## 1<sup>st</sup> Referee

## 2<sup>nd</sup> Referee

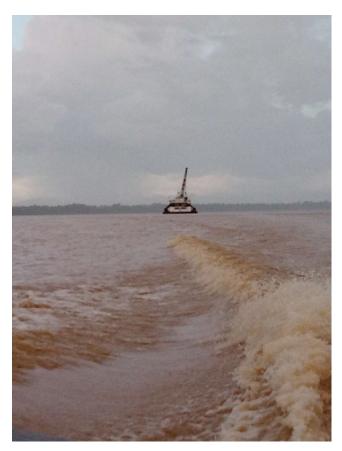
Page 11. Line 6 No supporting parameters like chlorophyll are presented that may clarify changes in PN quality. In this respect, I wonder about whether phytoplankton blooms occur? After all, fresh readily degradable organic matter is needed to create the anoxic microniches needed for denitrification. Please clarify this. Also, can you discern between sediment denitrification and water column denitrification?

Reply: Thank you. The Rajang water is very cloudy. The following photo is captured during the cruise. The water is very turbidity, especially in wet seasons.

Consequently, the terrestrial particles are the dominant composition in the entire estuary. The algae blooms were not observed. In the present study, concentration of chlorophyll was not included. In the same cruise, Dr. Patrick Martin measured the concentration and the data can be found in Martin et al., 2018 (same special issue). From their results, we can see that the concentration was low ( $<3~\mu g~L^{-1}$ ). In addition, PhD student, Edwin Sia, in Prof. Moritz Müller research group, measured the algae species during the cruises. The biomass in the estuary was much smaller than that in the coastal water. In the revised draft, we added the information that the PN was mainly from upper stream. The chlorophyll concentration was very low, on the basis of Martin et al. (2018).
